RECREATION TECHNICAL REPORT – DEPARTMENT OF CONSERVATION

Re: Waitaha Hydro Scheme: Technical Advice to inform S51 and S53 reports – November 2025

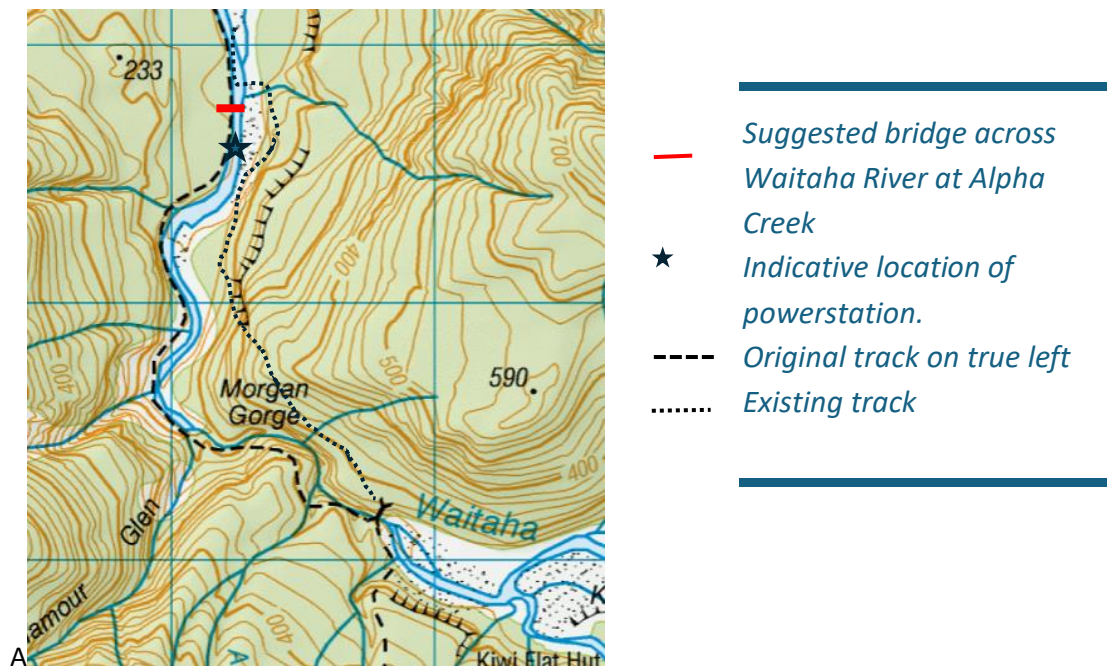
45. Overall, the mitigation proposed and the amount of compensation offered will not overcome the high degree of unmitigated adverse effects. The one-off payment neither reflects the scale nor duration of the residual adverse effects on trampers nor addresses the core effects on recreation values. Visual, noise, and perceptual changes from permanent infrastructure—and the loss of naturalness and solitude—remain unresolved. These outcomes are fundamentally inconsistent with CMS objectives for a Backcountry–Remote Zone, which require maintaining natural character, minimal mechanised access, and low facility provision. The proposal fails to avoid or meaningfully minimise these effects, and the compensation proposed is not considered effective.

47. The alternative track proposed by Westpower and identified as mitigation in the Greenaway [15-19] and Bently reports [58], does not effectively reduce exposure to the Power Station Site. District staff confirm that, although the alternative route would divert trampers before they reach the switchyard and tailrace and slightly increase their distance from the Power Station Site, the structure and associated infrastructure would remain visible from the track above the site. In addition, the alternative route adds approximately 30 minutes of travel up

a steep, muddy slope, making an already difficult section of the track heading into or leaving Kiwi Flat even more challenging.

48. Given that the effect cannot be avoided, a more practical solution—developed in consultation with the District Office—is for Westpower to reinstate and maintain the original track to Kiwi Flat on the true left of the river for the life of the scheme. Trampers could utilise the access road from MacGregor Creek to Alpha Creek, where a new bridge could be constructed downstream of Power Station Site. By crossing the Waitaha River at Alpha Creek, much of the infrastructure around the Power Station Site would be avoided.

49. Reinstating the track on the true left of the river would avoid the need for trampers to ascend the steep ridge to the terrace on the current track, which involves chains and ladders. The greater distance from the Power Station Site, combined with a low-profile design and vegetation screening, would further reduce visual and noise effects for those using the true left track. While trampers would still encounter the access road and views of the Power Station Site, the impact would be lessened by providing a potentially shorter route that allows quicker access to more remote areas—making this a more appropriate mitigation. Reinstating the track on the true left also creates the possibility of removing the swing bridge at Morgan Gorge, which currently overlooks the proposed weir and intake structures, thereby reducing visual impacts at Kiwi Flat.
